Case Number: R18058

CASE COMMENTS:

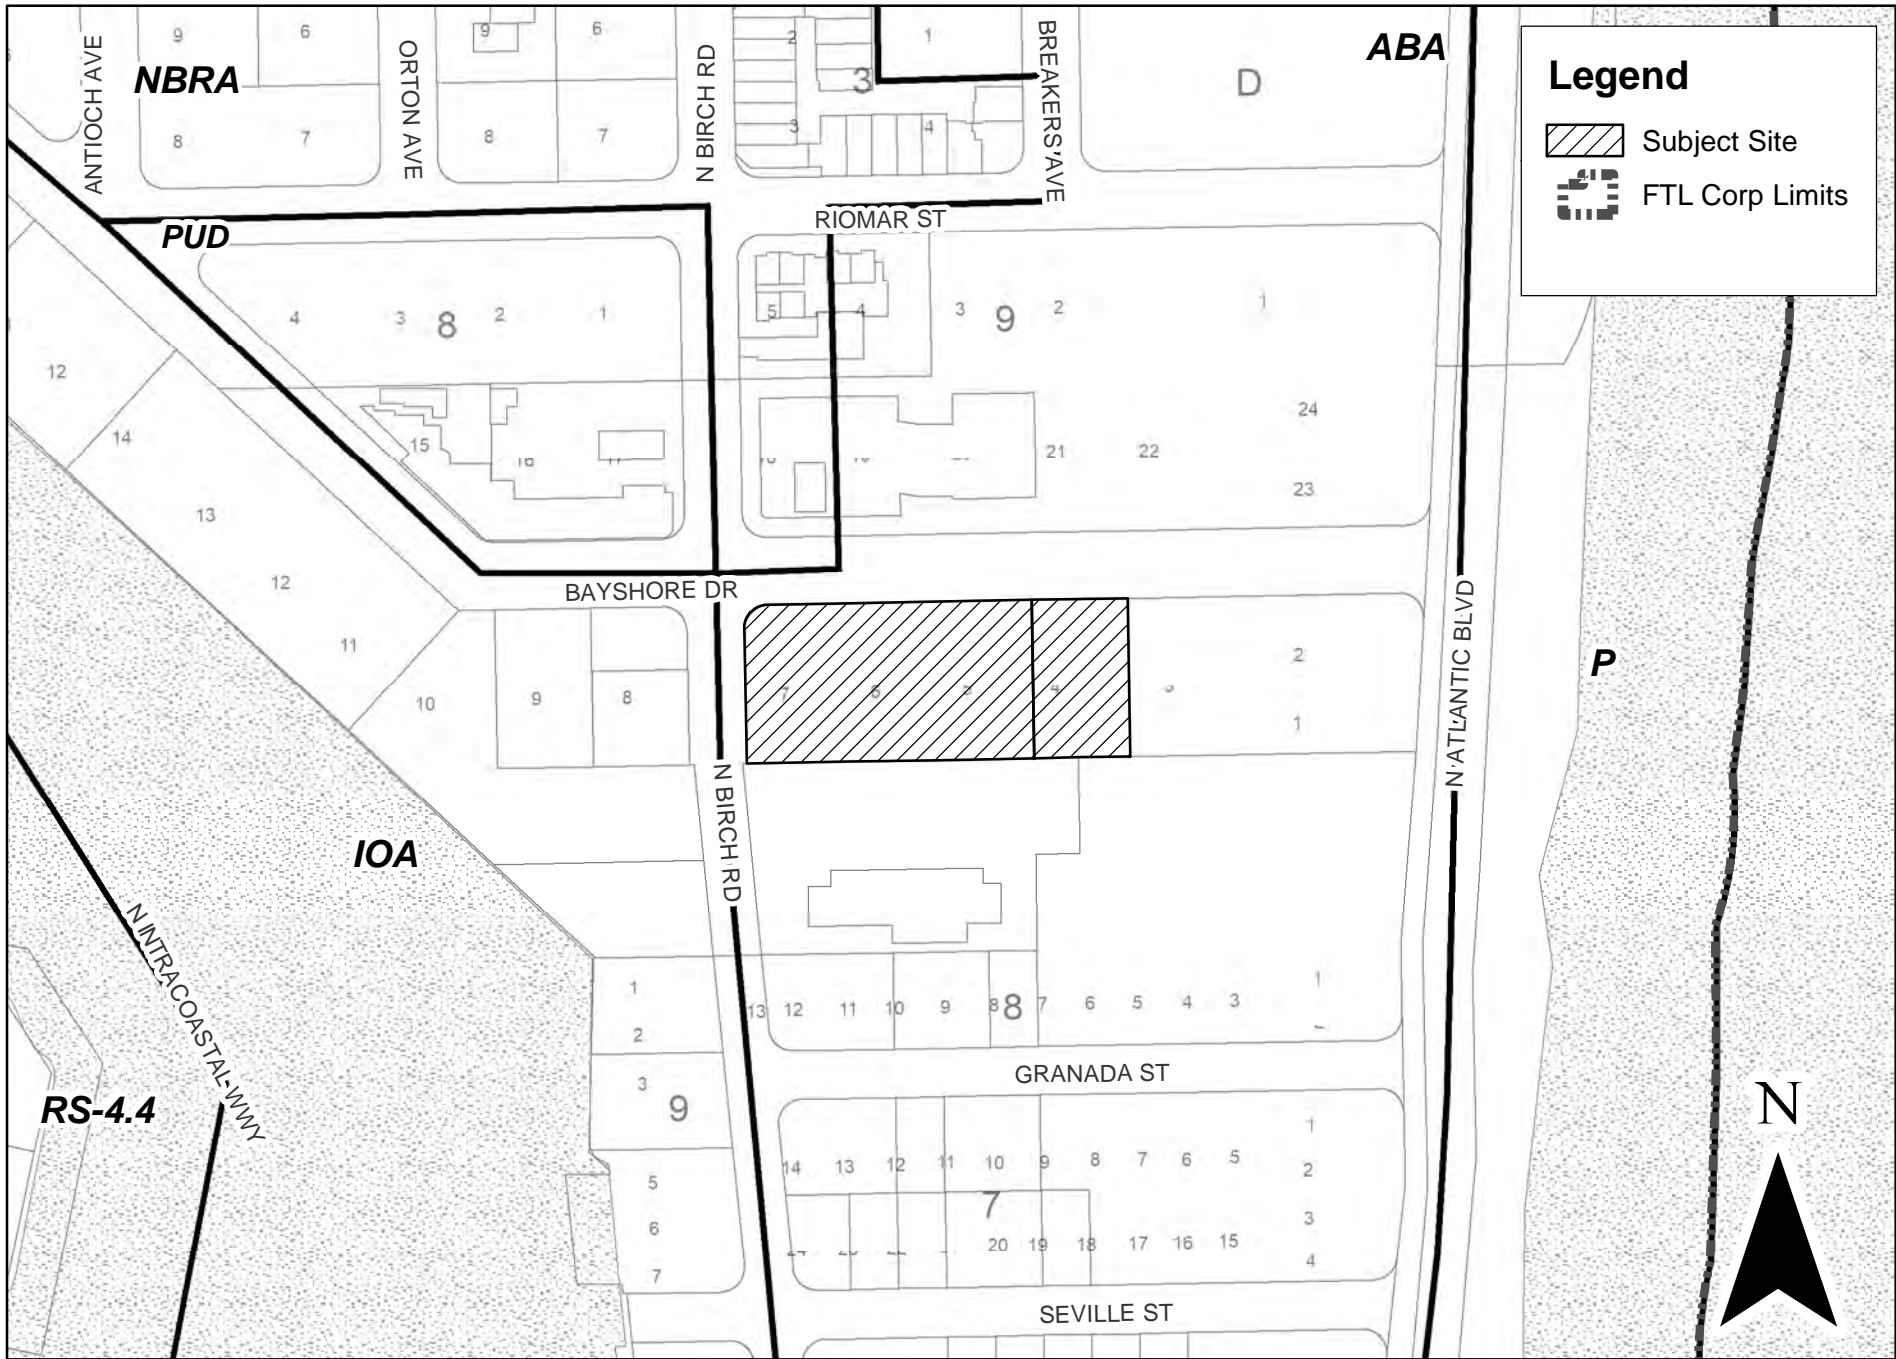
- a. **Provide context elevations** (north/south and east/west) indicating proposed project and nearby properties, including those across adjacent streets and/or waterways. Dimension the height, length, and width of all structures, setbacks, drive isles, landscaping, etc. in order to ascertain the relationship

the proposed development will have on the surrounding properties. Include a rendering of the proposed project as it would be viewed from the Las Olas Bridge.
